MEMO

Re: Zoning Map Amendment Application – Smart fields

Smart Fields Subdivision

Exhibit C

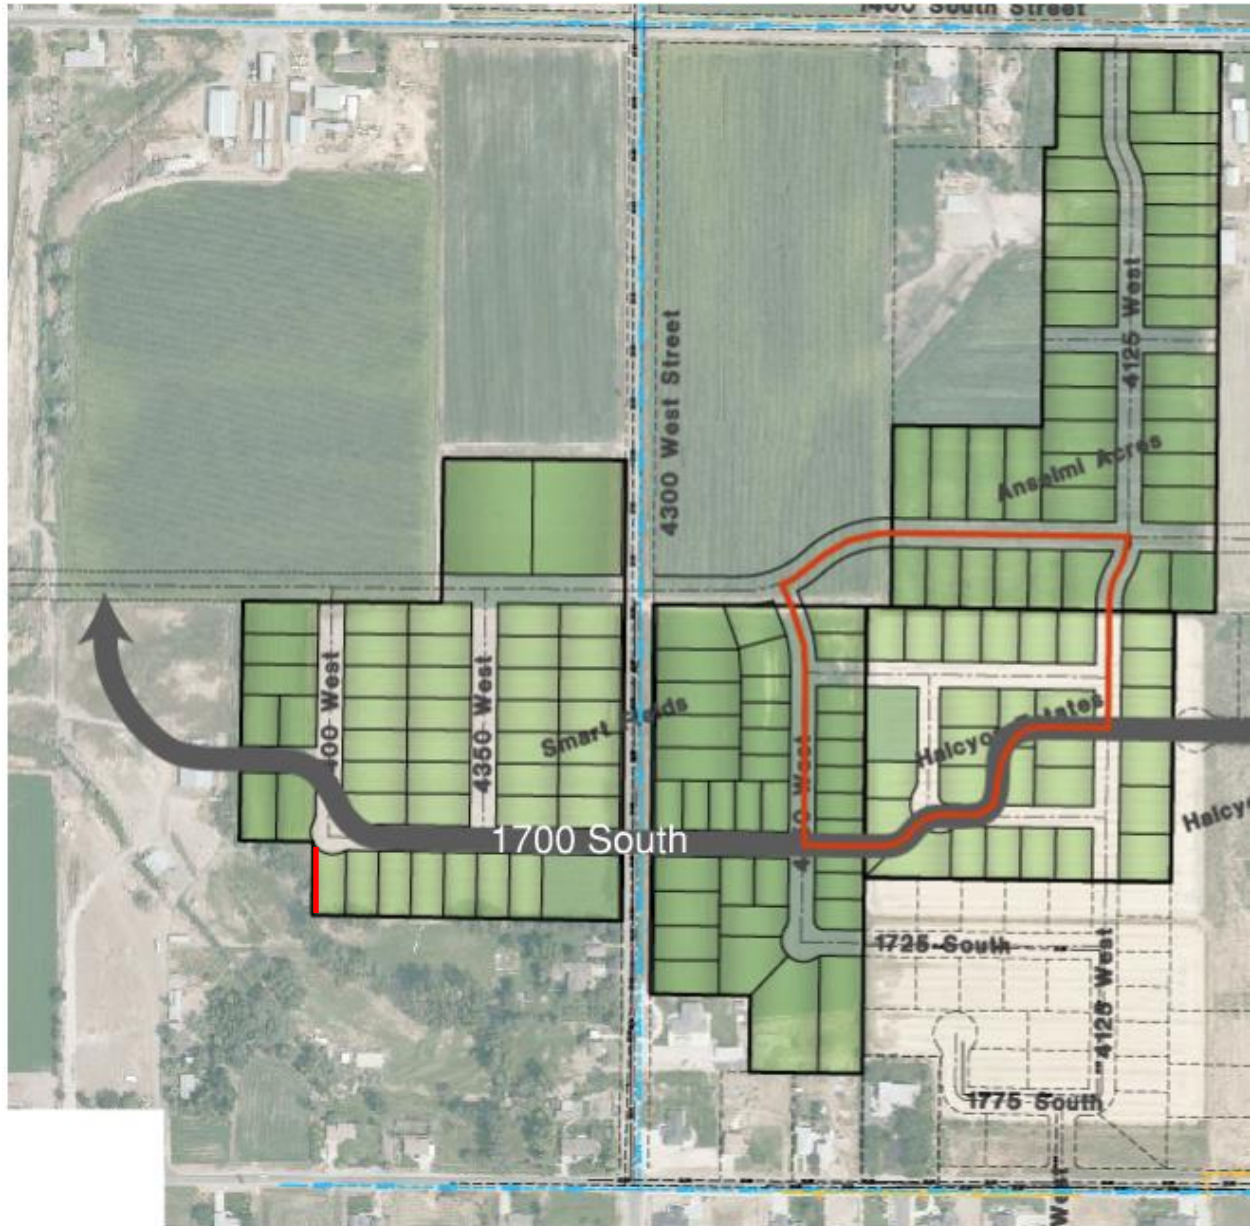
The Smart Fields Zoning Map Amendment was presented before the Planning Commission on March 14th 2023. In that meeting, the planning commission forwarded a positive recommendation to the County Commission with the conditions stated in model motion #2. The Smart Fields concept plan with the altered alignment of 1700 South and the approved model motion #2 are included with the memo as Exhibits C and D.
